COMPANY / PROJECT
ST185 CELICA GT-FOUR - LINK ECU CONVERSION

TITLE
R1 RETAINER CLIP

PART / DWG NO.	REV	MATERIAL
ST185-FB-104	**E.02**	PA12 (SLS / MJF)

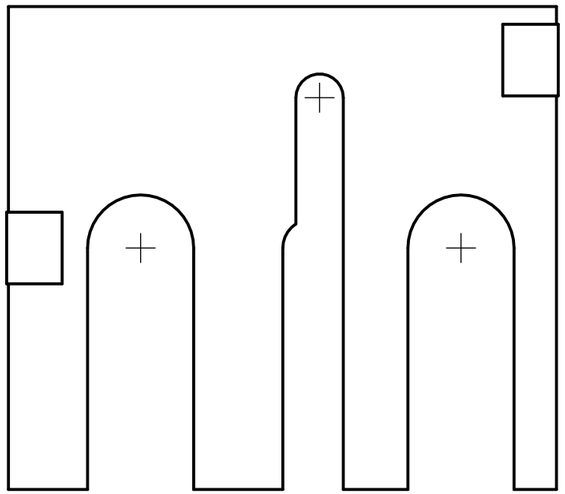
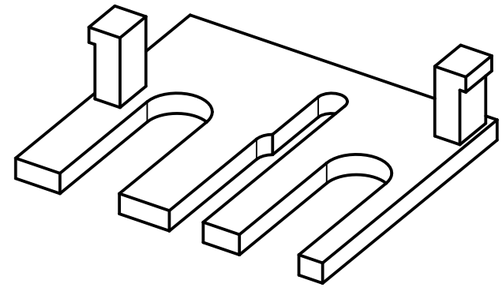
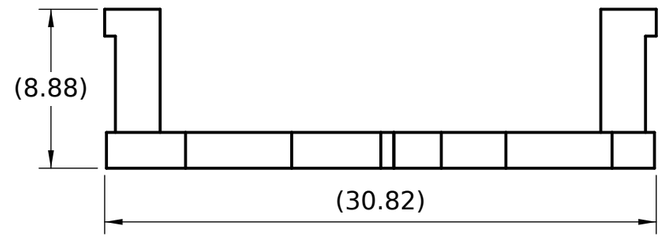
REVISIONS			
REV	DESCRIPTION	BY	DATE
A	Initial	DG	15/10/26
B	Clip leg fix (#266)	DG	15/10/26
C	R127 amendment: outer walls grown outward to 4.3, curved bend saddles back (#271); first drawing issued (#280)	DG	16/10/26
D	Dan's markup 17/10/26 (23-26): wire holes become slots open to the front edge - the clip slides onto the crimped wires	DG	18/10/26
E	Fit audit 18/10/26 (R165): legs on the hole-zone edge, plate ends + 1.0 (turned R1 30 terminal)	DG	18/10/26
